Illinois Department of Transportation

SUBJECT: St. Louis Downtown Airport
Cahokia Heights, Illinois
St. Clair County
Illinois Project Number: CPS-4833
SBG Project Number: 3-17-SBGP-TBD
Contract No. SD062
Item No. 06A, 3/08/2024 Letting
Addendum A

NOTICE TO PROSPECTIVE BIDDERS

**RECONSTRUCT
ACCESS ROAD:
CURTISS STEINBERG
DRIVE, PHASE 2**

**MAINTENANCE OF
TRAFFIC PLAN
PHASE 1**

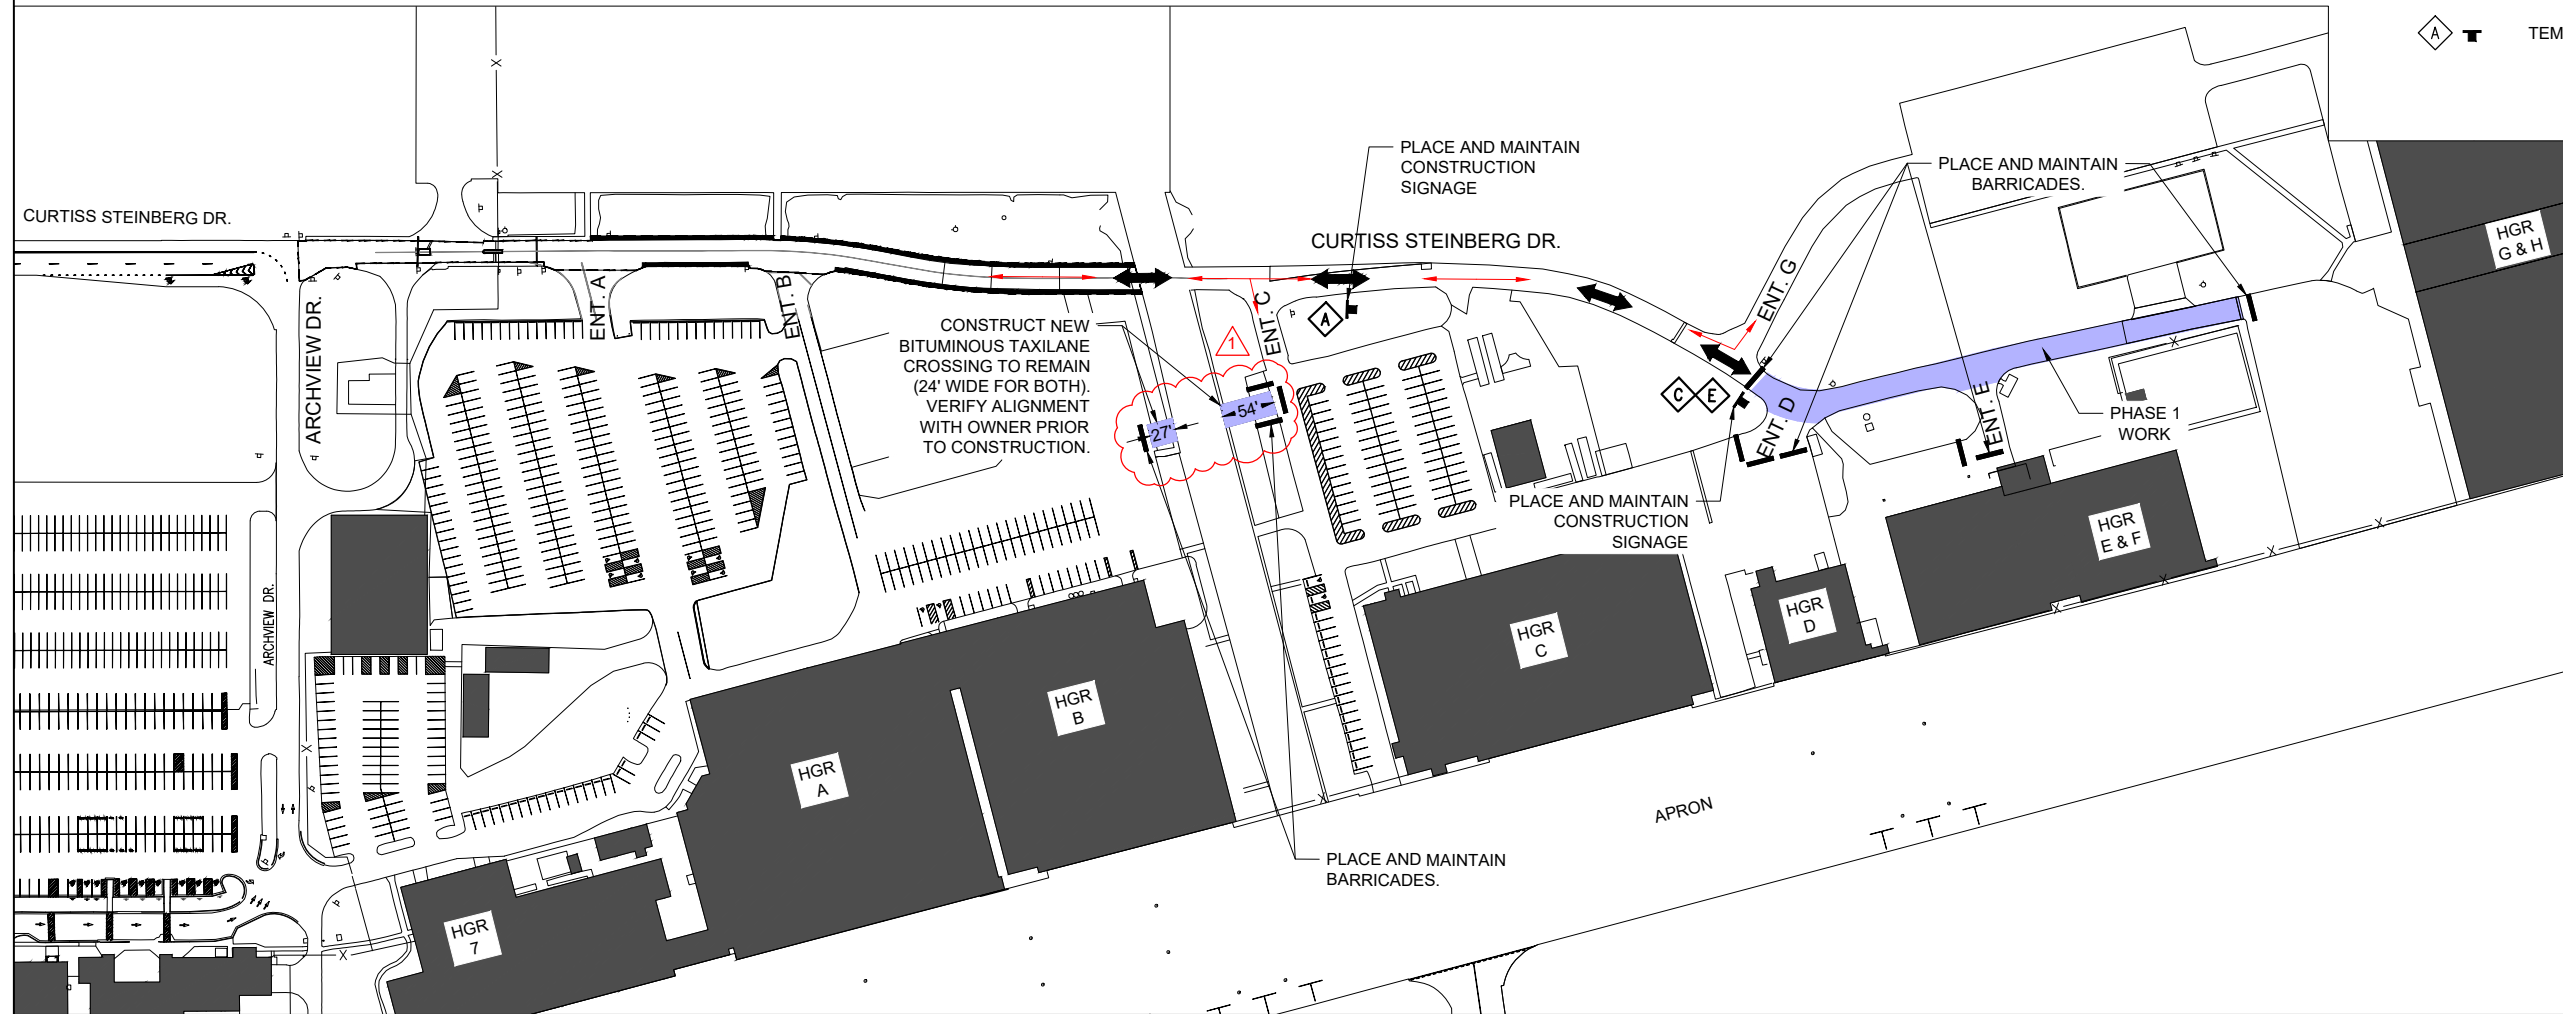
Revisions to Plans to delete one (1) proposed roadway sign relocation;
Revisions to Plans to shift the location of the proposed taxi lane crossing pavement;
Addition of new scope included as Additive Alternate No. 1.
